Regulation No. 65 (Special warning lamps)

Proposal for Supplement 10 to Regulation No. 65 (Special warning lamps)

Submitted by the expert from Germany*

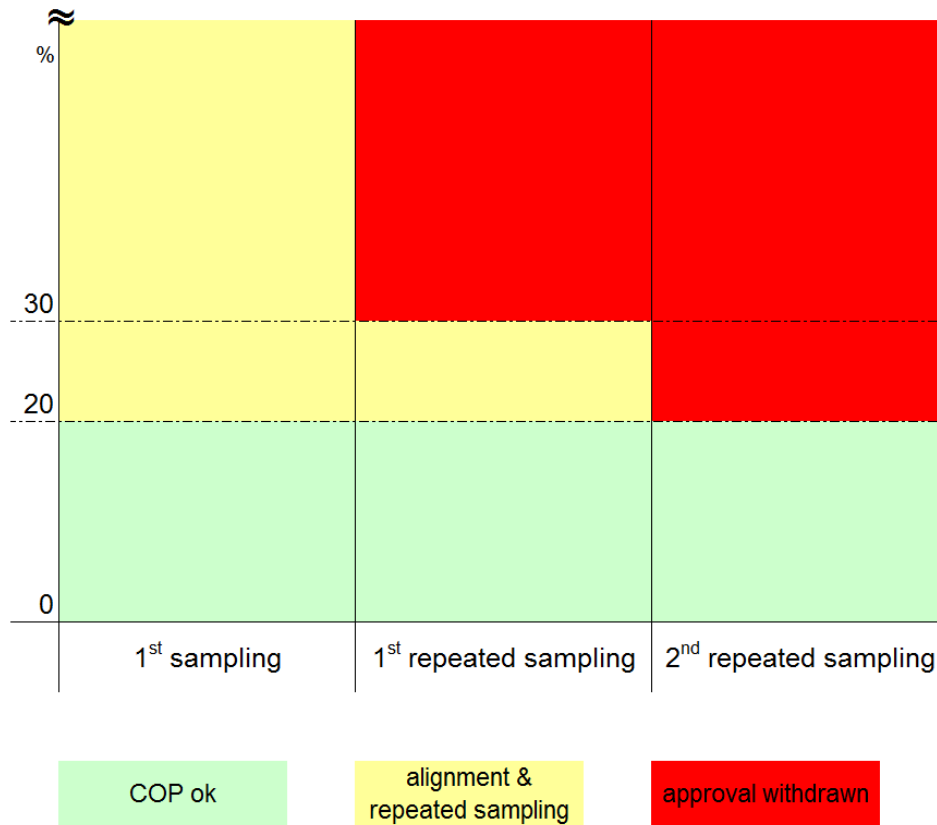
6. COP is now described in a clear stepwise process (with limited steps), which gives the manufacturer the chance in the first step - in the case of deviations of more than 20% - to align his production process. Also the COP process could be completed earlier, when the first two samples are in the full specifications.

8. The attached drawing shows this stepwise process.
